**PLANNING DEPARTMENT ADMINISTRATIVE PUBLIC HEARING
SUMMIT COUNTY, UTAH
September 3, 2026**

Planning Department Staff Report

Subject: 1120 Park Avenue
Application: PL-26-06996
Authors: Jacob Klopfenstein, Planner II
Lillian Zollinger, Planner III
Date: September 3, 2026
Type of Item: Historic District Design Review

NOTICE OF PLANNING DIRECTOR ACTION

SITE PLAN
1/8" = 1'-0"

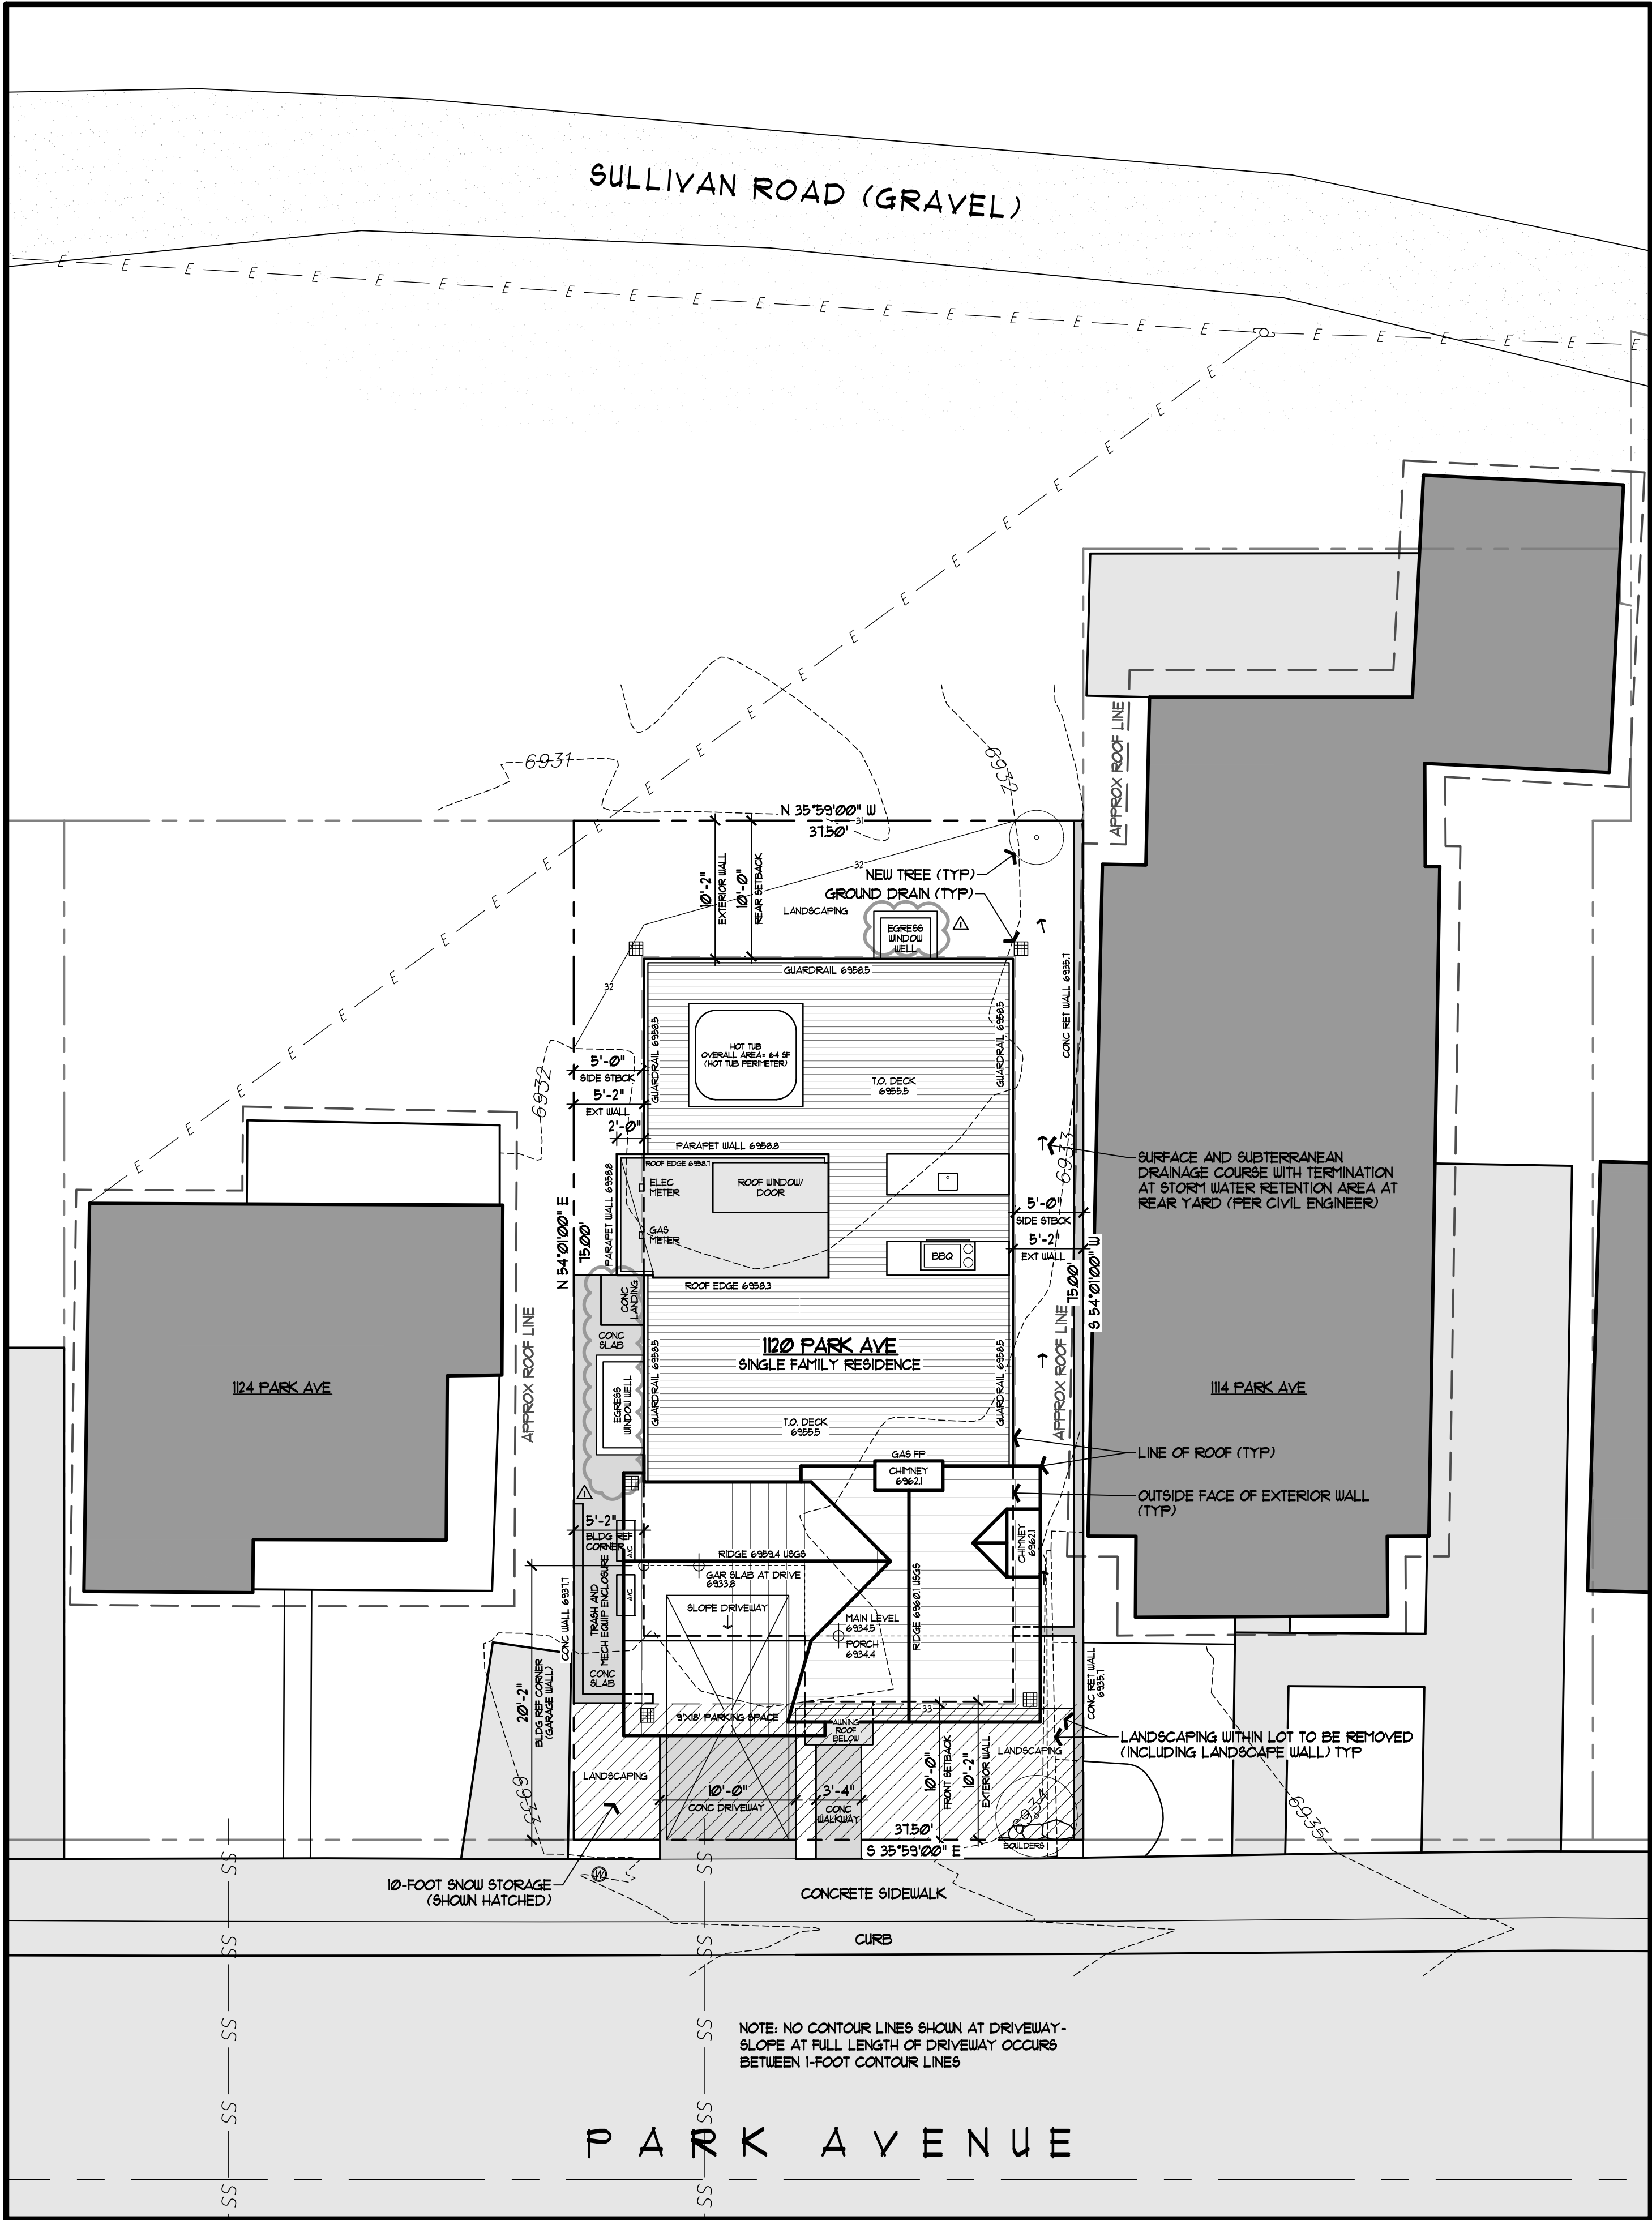
- i. The Applicant proposes a window well that encroaches into the five-foot north Side Setback.
 - ii. Per the Building Department, emergency egress is not required for the Game Room, where the window well use is proposed.

- iii. Staff recommends Condition of Approval 8, wherein the window well shall be removed from the plans or updated to comply with IBC requirements as reviewed and required by the Building Department, prior to submitting a building permit.

8. The Applicant shall update the plans to remove the window well in the north side Setback or update the plans to comply with the minimum requirements of the IBC as reviewed and required by the Building Department prior to building permit submittal.
